Response to the Region of Waterloo Hallman Pit Hydrogeology

Jackson Harvest Farms Ltd.

July 14 2020

REF. No. 1728

Nitrate In Groundwater

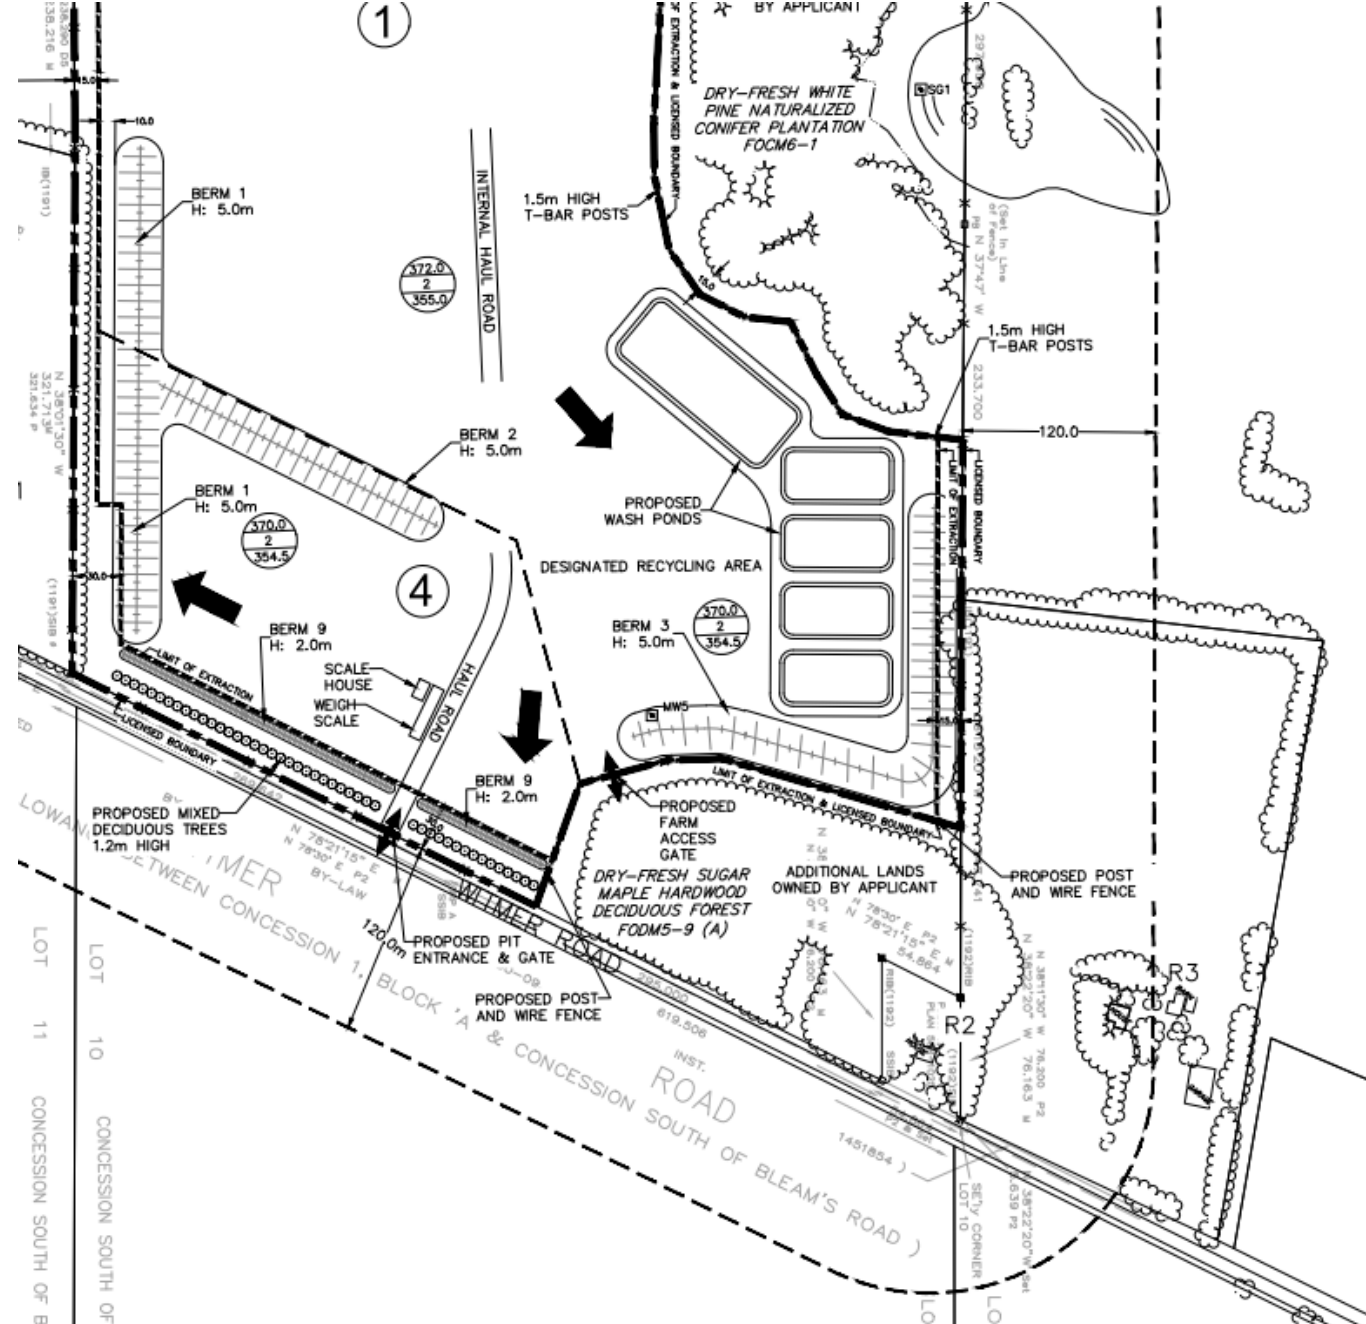
- XXVIII. Section 4.4 of the report indicates that nitrate concentrations in the area of MW2 are from off-site sources. The report did not provide any interpretation of groundwater quality across the rest of the site or potential on-site nitrate sources.

On-site testing by Harden Environmental and off-site testing by Burnside and Associates is shown on Figure 6. The on and off-site testing find that the nitrate contamination is widespread and similar concentrations of nitrate are observed off-site as found on-site.

FIGURE 1. SG1 Pond Hydrograph & Proposed Water Level Triggers.

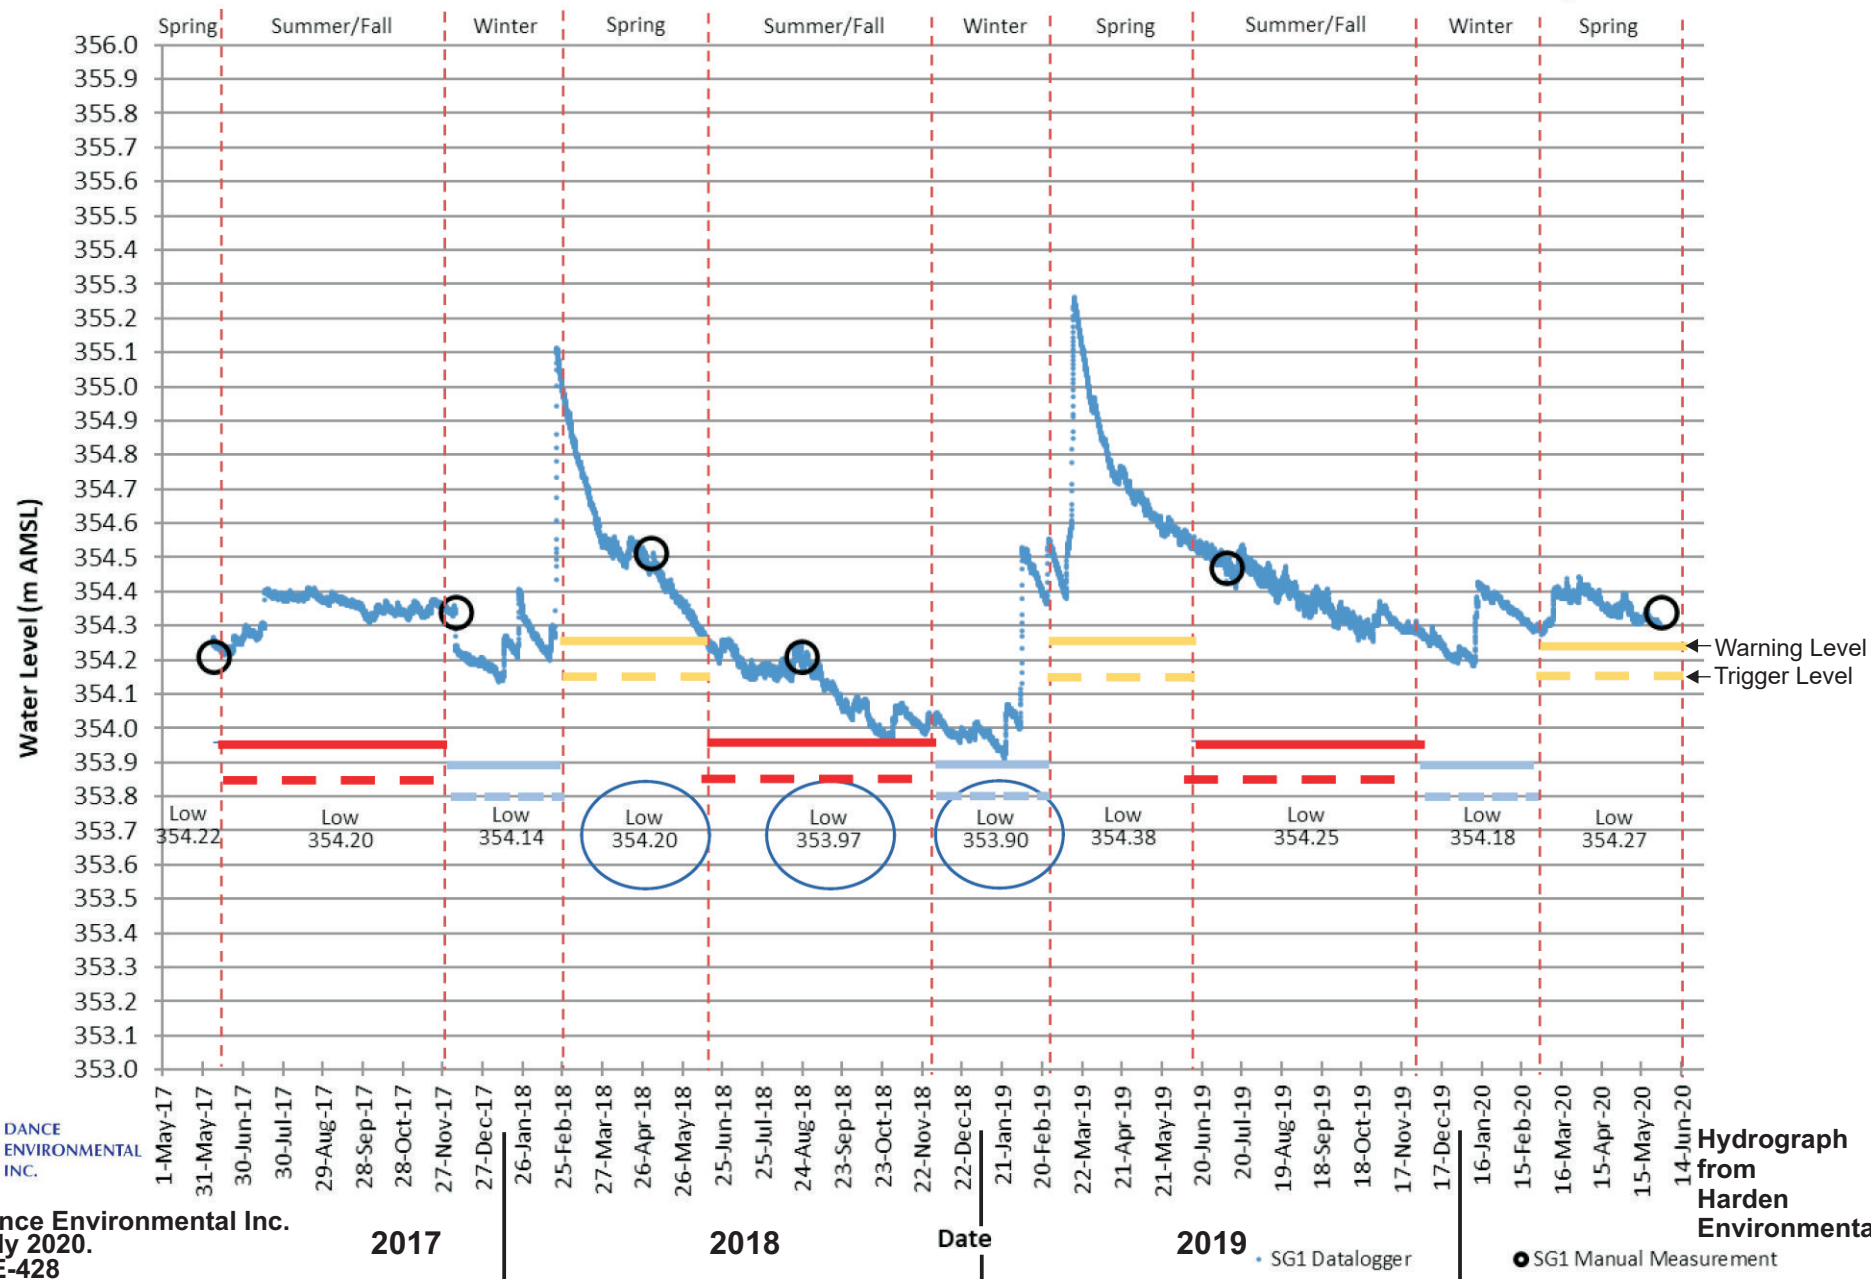
In the GRCA comment letter dated December 6, 2019, it was indicated that the GRCA recommended that seasonal water level triggers be identified for the wetland and that a Contingency Plan be developed and implemented, as needed.

Figure 1 shows the warning level (historical lowest level measured) as a solid horizontal line for each season. The dashed line, set at 10cm below each warning line, is the proposed trigger level. The trigger set at 10cm below the warning level avoids frequent trigger exceedances due to weather-related reductions in pond levels in the future. Such events are expected because of continued record high temperatures and lack of rain that result in pond drawdowns that have become a pattern in the last 5 or more years.

As shown on Figure 1, the seasonal warning values would be: Spring 354.20m; Summer/Fall 353.97; and Winter 353.90, with seasonal trigger values being 10cm less than the warning elevations.
